Proposal Request

AWSOM

PROPOSAL REQUEST 118

Gallery Cane Detection Rail

L1 - NOTE PLAN - AREA A
1/8" = 1'-0"

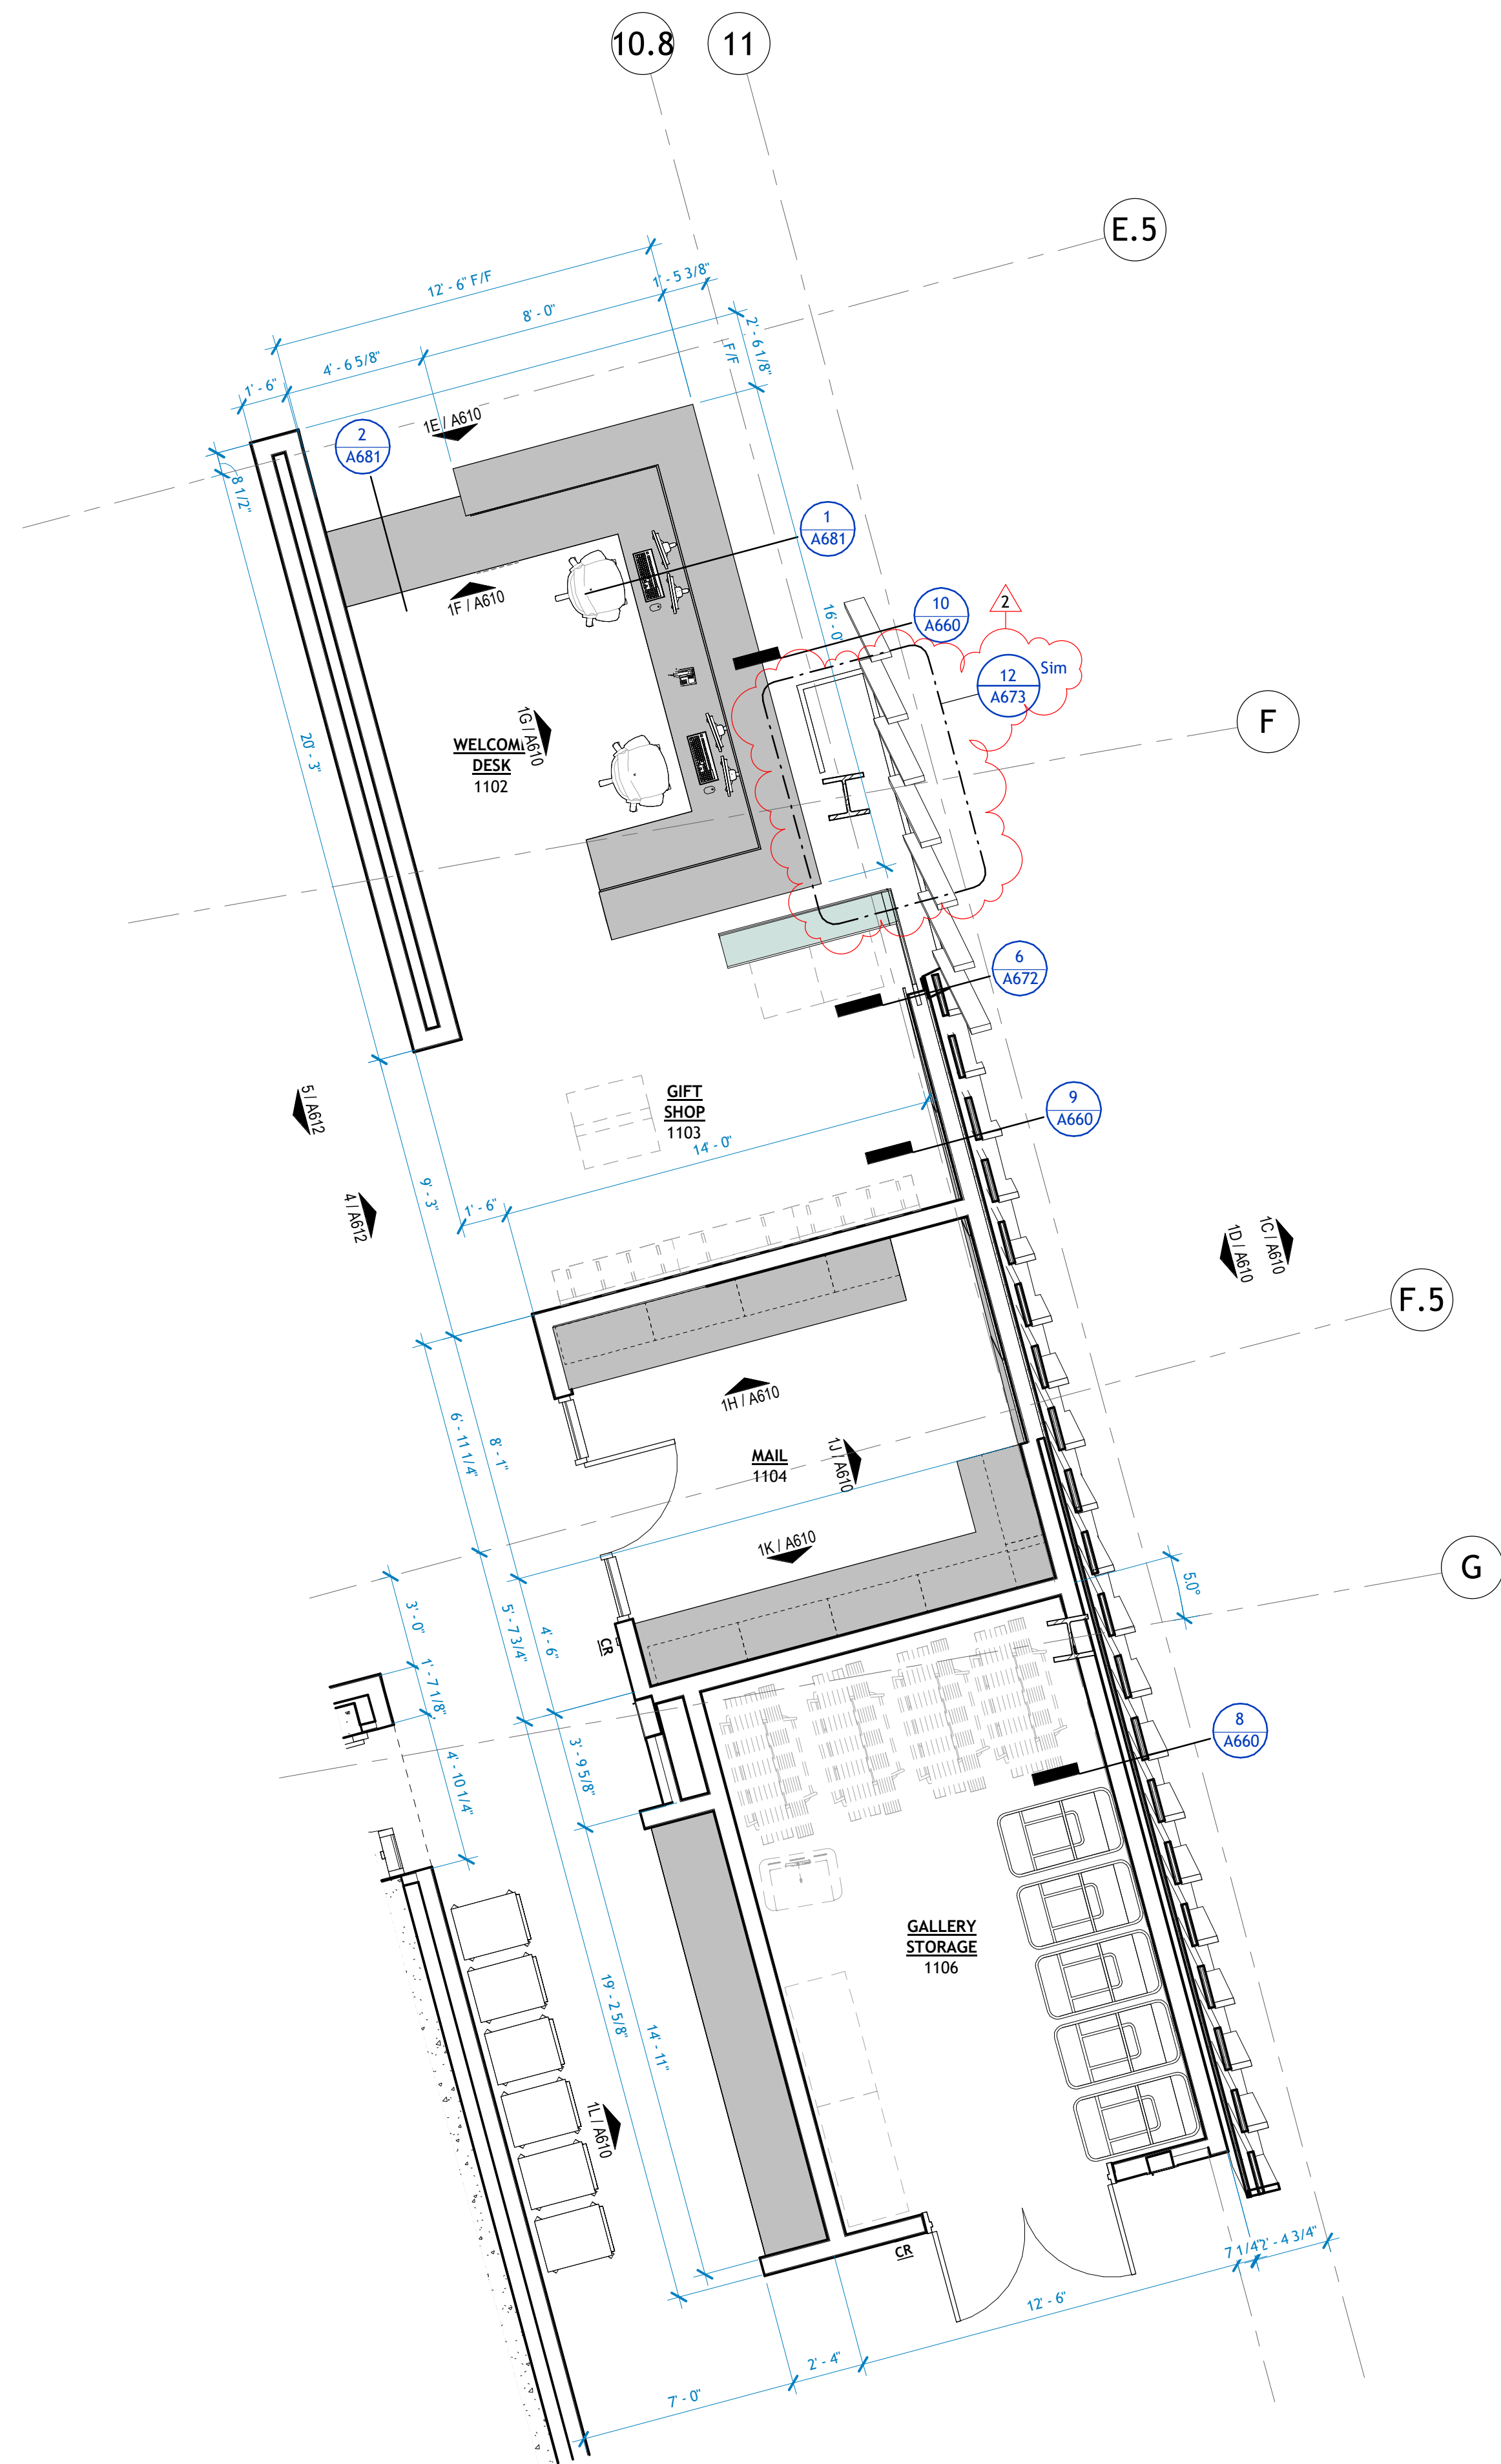
- a) Refer to Revised Sheet **A101A**, with original issue date 02.24.2023 and revised date 04.14.2025.
 - **Detail 1,**
 - (1) Added callout for Cane Detection Rail
- b) Refer to Revised Sheet **A610**, with original issue date 02.24.2023 and revised date 04.14.2025.
 - **Detail 1,**
 - (1) Added callout for Cane Detection Rail
 - **Detail 1D**
 - (1) Added notes for cane detection rail and extents.
- c) Refer to Revised Sheet **A672**, with original issue date 02.24.2023 and revised date 04.14.2025.
 - **Detail 6,**
 - (1) Added callout and note for Cane Detection Rail
- d) Refer to Revised Sheet **A673**, with original issue date 02.24.2023 and revised date 04.14.2025.
 - **Detail 12 and 12A,**
 - (1) Added plan and section details at cane detection rail.

12 | GALLERY CANE DETECTION RAIL
3/4" = 1'-0"

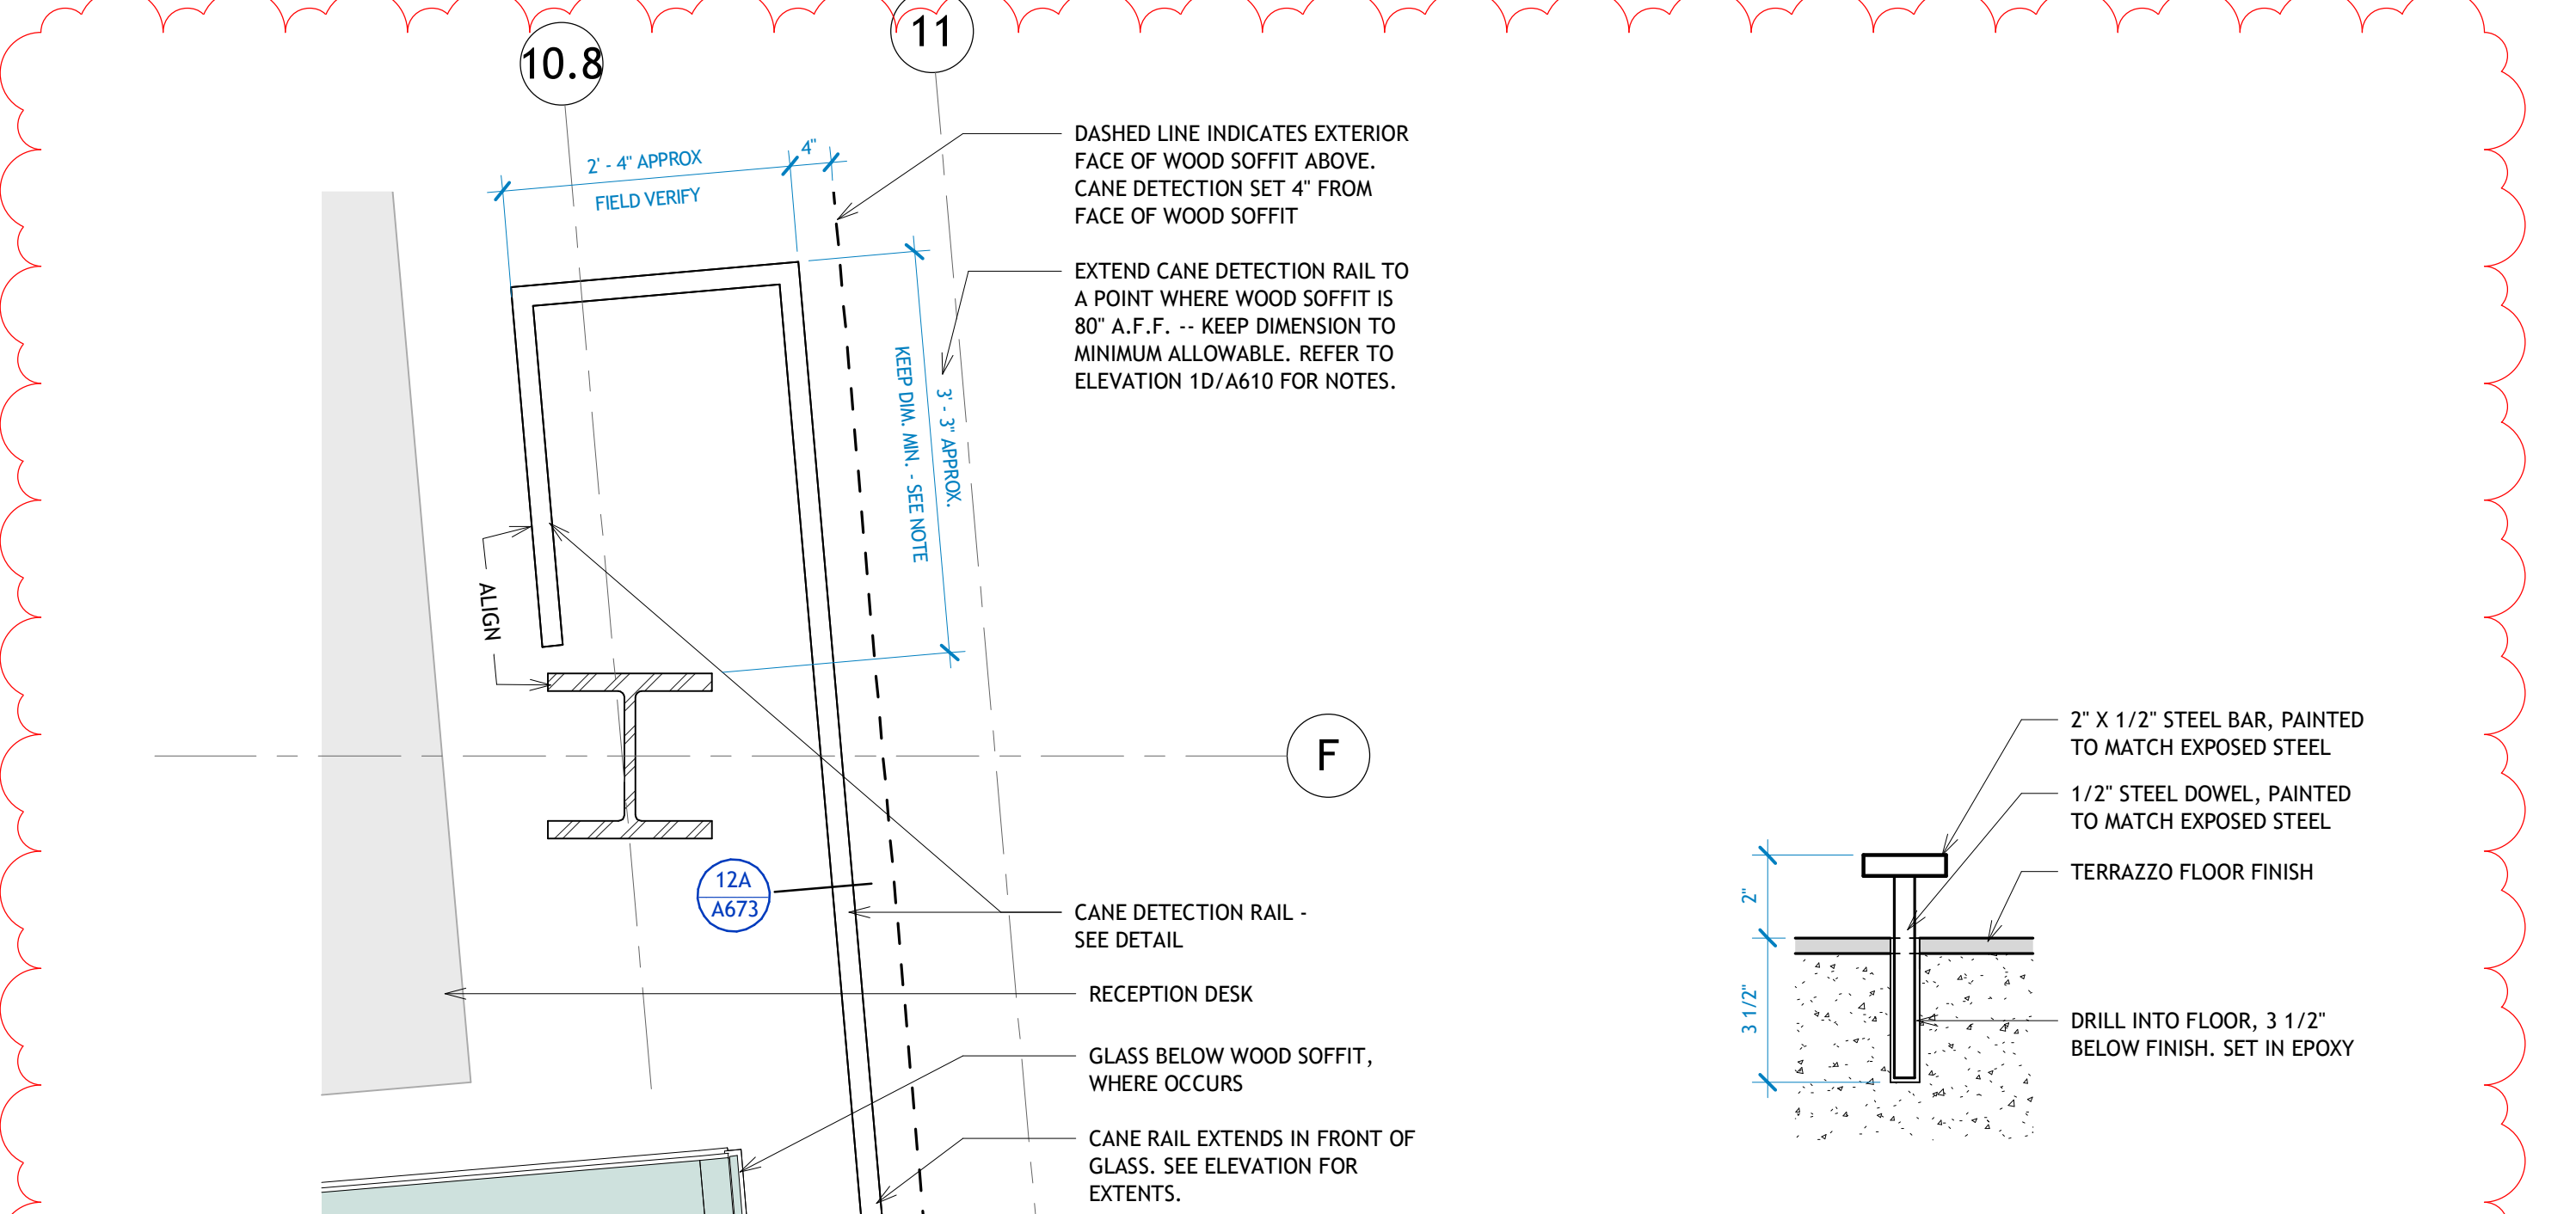
This PR adds a cane detection rail below the gallery wood wall where it floats above the floor. This cane detection rail is required in code in circulation paths where projections are lower than 80" AFF and extend more than 4" in front of a wall or solid surface.
